UNITED STATES PATENT AND TRADEMARK OFFICE

| APPLICATION NO. | FILING DATE | FIRST NAMED INVENTOR | ATTORNEY DOCKET NO. | CONFIRMATION NO. |
|-----------------|-------------|----------------------|---------------------|------------------|
| 09/847,759 | 05/02/2001 | Mark J. Hall | HANBEV.002RA | 6043 |

| Office Action Summary | Application No. 09/847,759 | Applicant(s) HALL, MARK J. | |

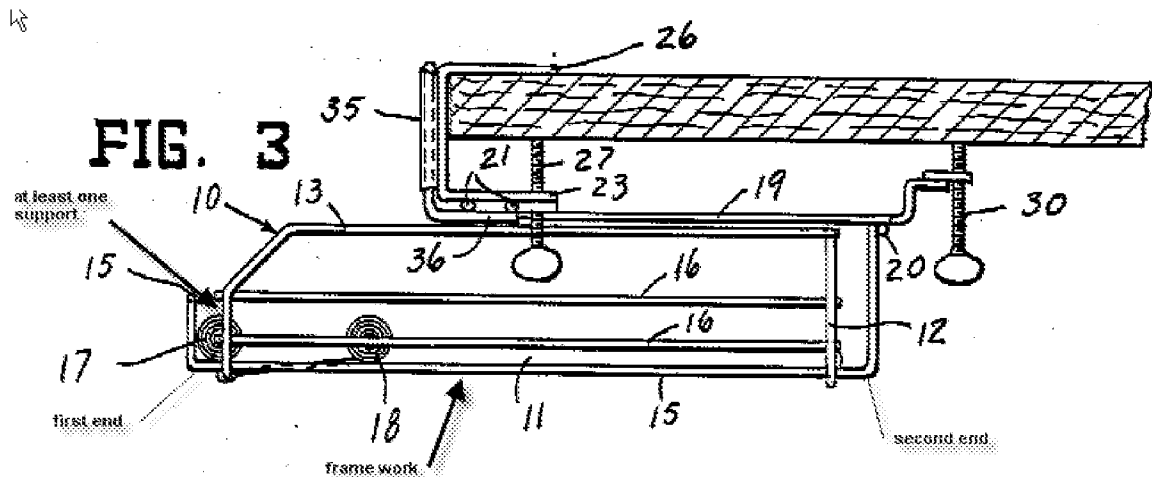
Claims 5, 18 and 56 are rejected under 35 U.S.C. 102(b) as being anticipated by Dickson (US 3007580). Dickson discloses a shelf structure 10 comprising:

a front rod member 21 and at least one other rod member 21 rearwardly spaced from the front rod member and, together with the front rod member, defining a first plane;

a framework (not numbered, but shown in figure 3) defining a second plane; and

at least one support (not numbered, but comprising one of the vertical portions of the rod 13) connecting at least the front rod member and the framework, wherein at least a portion of the framework (not numbered, but shown in figure 3) extends at least forward of a projection 36 of the front rod member 21 thereon with a stop comprising the U-shaped portion of 15, the stop extending in a direction from the second plane with at least a component toward the first plane, and

wherein the framework comprises further rod members 15 each having a first end (labeled below) and a second end (labeled below) and extending from the first end at the stop to the second end that is rearward of a rearward most one of the at least one other rod member 21,

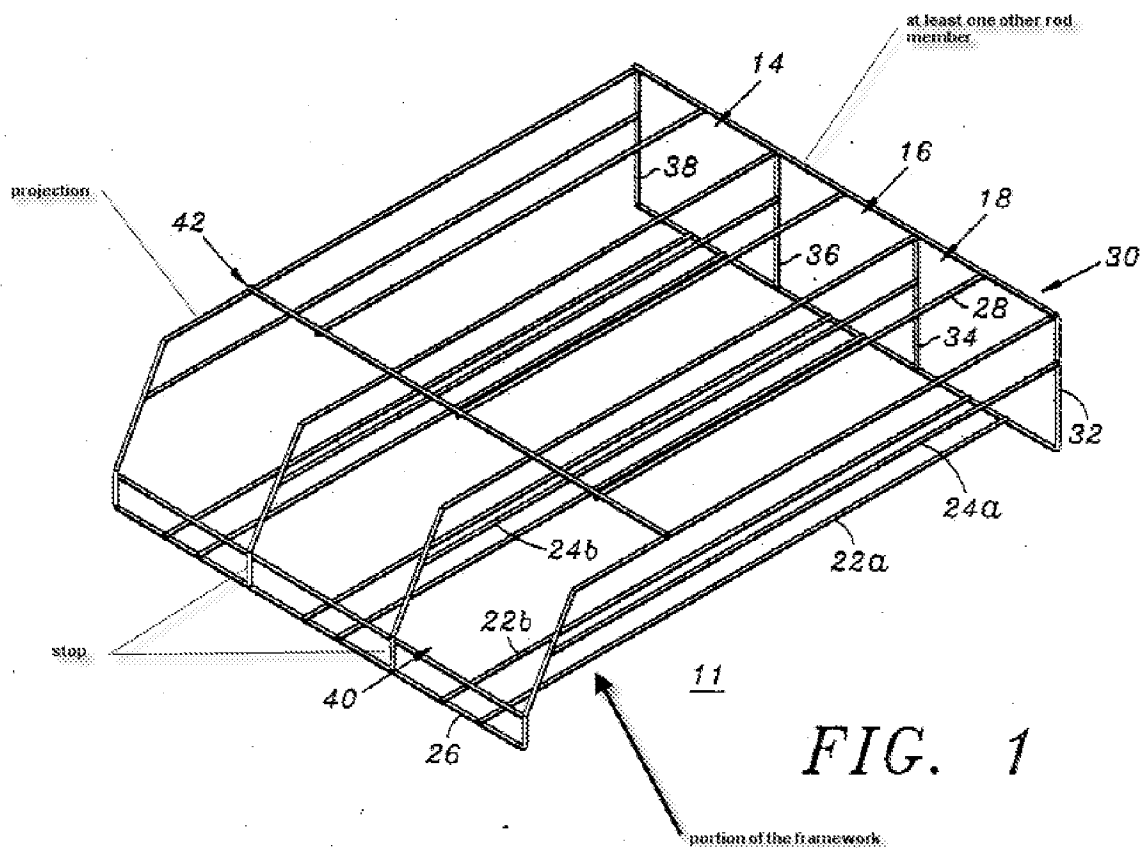
However, Buday discloses a shelf structure 11 configured to rest on and engage one of the shelves which is horizontal or inclined, the shelf structure comprising:

a front rod member 42 and at least one other rod member (not numbered, but shown in figure 1 at the rear of the shelf structure 11) rearwardly spaced from the front rod member 42 and, together with the front rod member 42, defining a first plane and configured to support additional shelving above the first plane;

a framework 22a, 22b defining a second plane; and

at least one support 32 connecting at least the front rod member 42 and the framework 22a, 22b, wherein at least a portion of the framework (not numbered, but shown in figure 1) extends at least forward of a projection (labeled below) of the front rod member 42 thereon with a stop (not numbered, but comprising one of the rods extending between the rod 26 to the rod extending above and parallel to the rod 26), the stop extending in a direction from the second plane with at least a component toward the first plane;

at least one member 34 connecting the front and other rod members (claim 2);

the at least one support 32 along with the support 38 comprise legs extending from opposite ends of the front rod 42 and the rear rod (claims 3 and 4);

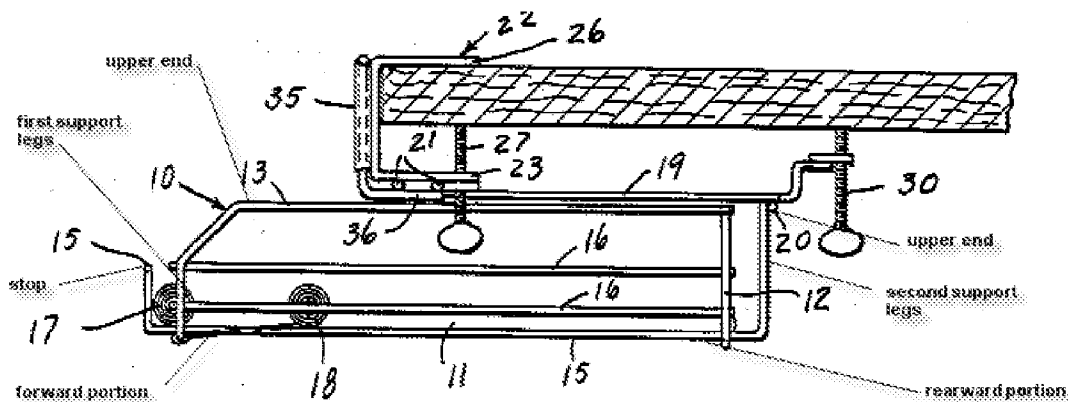
Dickson discloses a rack 10 comprising

a support assembly 15 having a forward portion (labeled below) and a rearward portion (labeled below) and being configured to support a plurality of beverage containers;

a first pair of support legs (labeled below) having lower ends connected to the forward portion;

and a second pair of support legs (labeled below) having lower ends connected to the rearward portion, each of the first and second pairs of support legs having upper ends (labeled below) configured to hang the rack from a shelf disposed above the rack;

a stop (labeled below) disposed at the forward portion of the support assembly,

wherein the first and second pairs of support legs are sized, i.e., the second pair of support legs are longer than the first pair of support legs, such that the forward portion hangs lower than the rearward portion when the rack is hanging, by the upper ends of the first and second pairs of the support legs, from a horizontal shelf. It should be noted that the rack 10 of Dickson, although not shown, is capable of hanging with the front portion lower than the rear portion by merely adjusting the threaded fastener 30

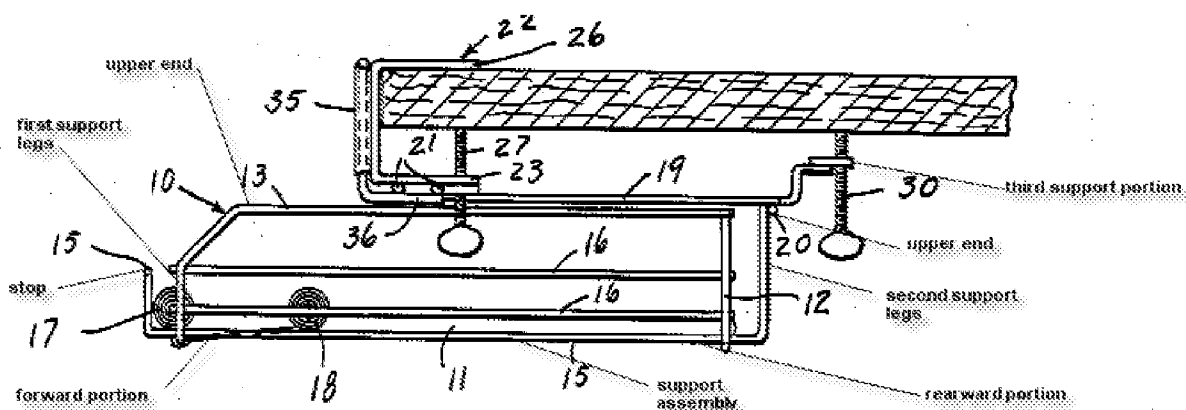
a support assembly (labeled below) having a forward portion (labeled below) and a rearward portion (labeled below), the support assembly defining a support surface configured to support a plurality of cylindrical beverage containers;

a stop (labeled below) disposed at the forward portion of the support assembly;

first and second support portions 22 disposed at the forward portion of the support assembly, the first and second support portions including upper ends, respectively, adapted to be disposed above the plurality of cylindrical beverage containers supported on the support surface;

at least first and second apertures (not numbered, but comprising the apertures through which the fasteners 27 extend) disposed adjacent the upper ends of the first and second support portions, respectively, the first and second apertures being configured to receive fasteners 27 for supporting the forward portion of the support assembly from a shelf 32 above the support assembly, the first and second apertures being spaced rearwardly from the stop;

a third support portion (labeled below) disposed at the rearward portion of the support assembly, the third support portion including an upper end (not numbered, but shown in figure 3); and

at least a third aperture (not numbered, but comprising the aperture through which the fastener 30 extends) disposed adjacent the upper end of the third support portion, the third aperture being configured to receive a fastener 30 for supporting the rearward portion of the support assembly from a shelf above the support assembly;

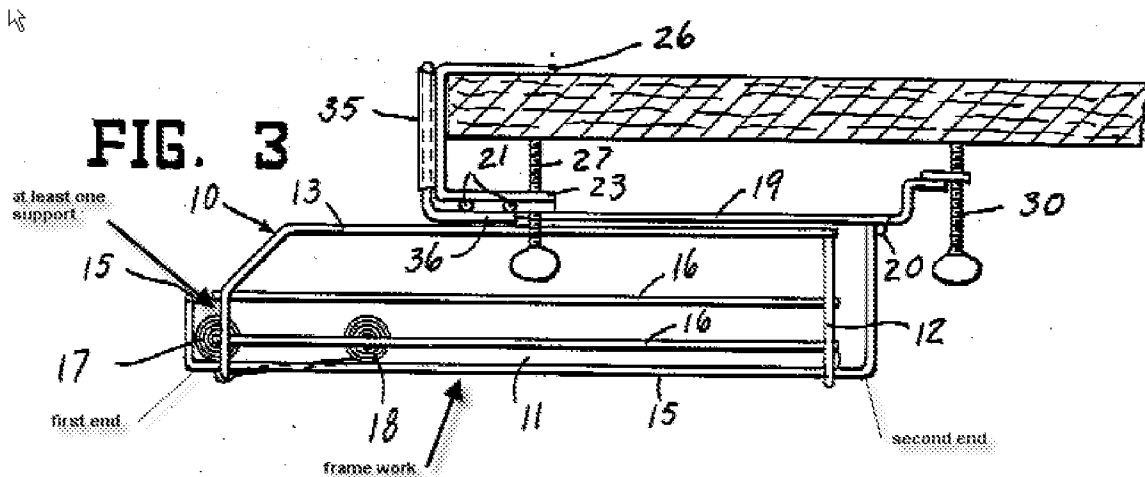
Claims 60 and 61 are rejected under 35 U.S.C. 103(a) as being unpatentable over Dickson in view of Lockwood as applied to claims 57-59 above, and further in view of Wagner (US 4700849). Wagner discloses a support assembly comprising horizontally extending plates 20 and 22 each including two apertures for attaching the support assembly to a support 60 disposed above the support assembly.

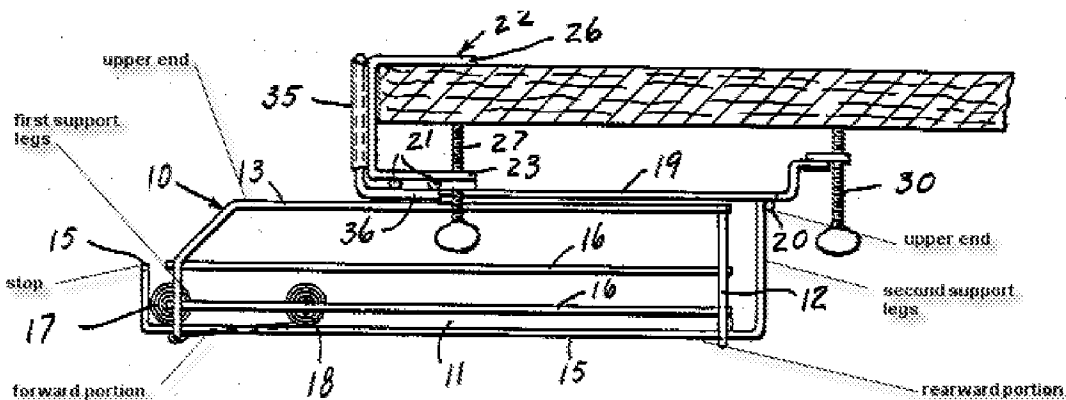
With respect to the applicant's comments concerning Dickson, the examiner respectfully disagrees. Dickson, in figure 1 and 3 shows at least one support connecting the front rod member 21 to the framework. The at least one support comprises the vertical portion of the rod 13 as shown in figure 3 below.

Additionally, Dickson, as shown in the figure below, discloses first support legs which are shorter than second support legs and the entire shelf structure 10 can be positioned such that the first support legs are lower than the second support legs via the screw 30 when the shelf structure 10 is hanging from a shelf.

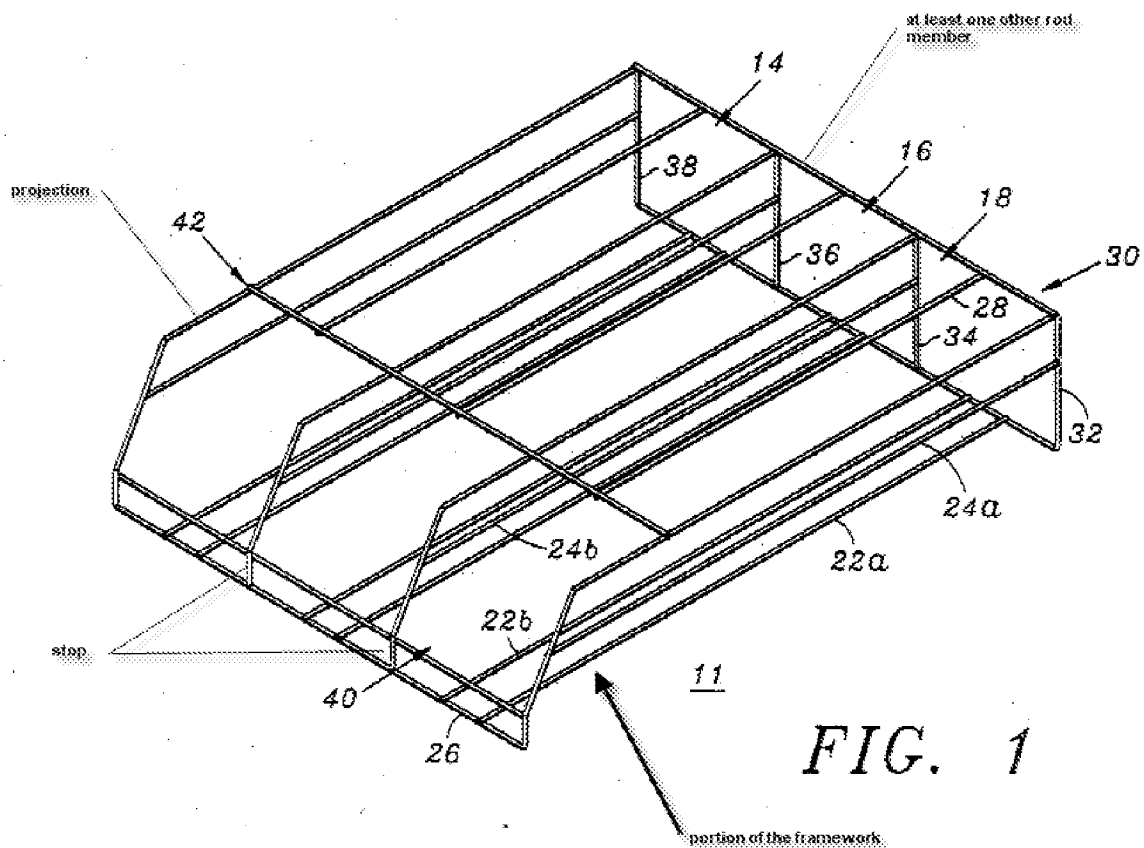
With respect to the applicant's comment concerning the rejection of claims 1-4, 15-17, 53 and 62 as being unpatentable over the admitted prior art in the preamble of Jepson claim 1 in view of Buday (US 5240124), the examiner respectfully disagrees. As shown in figure 1, Buday discloses at least one support 32 which connects the front rod member 42 via the members 28 to the framework 22a, 22b. The applicant's argument to the contrary is analogous to arguing that a person's foot is not connected to his/her head.
